Technical change to BEST

The component holder BEST is used for fitting electronic components. It replaces the disconnect lever or fuse holder of disconnect terminals or fuse terminals.

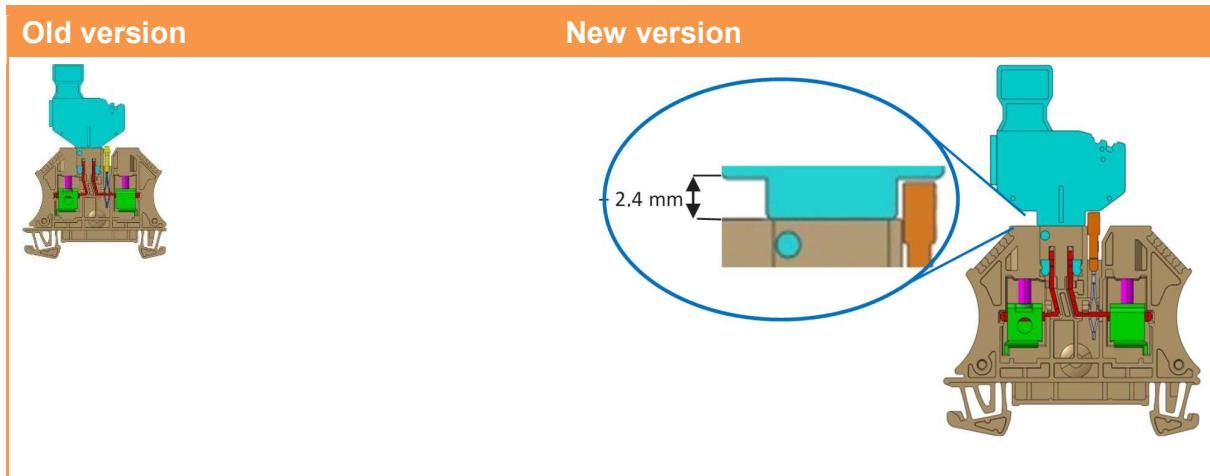
2. Technical change

Height: unmodified
Unique identification of the "new" BEST: engraving "2018"

The component holder BEST has been modified, as the pluggable cross connection for the A series is 2.4mm higher, due to the target to get only one pluggable cross connection ZQV...N for the A series & the W series.
